Subject: 2024/1122/P

Comments in response to the legal advice uploaded on 10.10.2024

Comments on the Basement Impact Assessment Rev 2.3

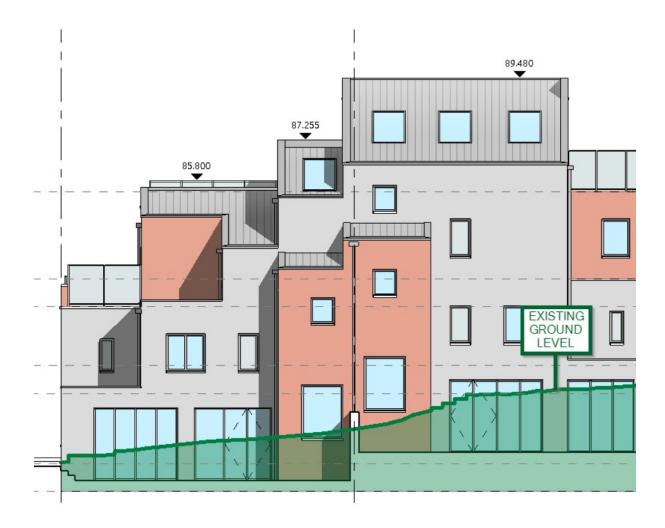
Viewed from the south each flat has four storeys not three. Viewed as one building because the scheme is stepped, shown below, it actually appears as at least five storeys. It is wrong to portray this as a three-storey low-level development.
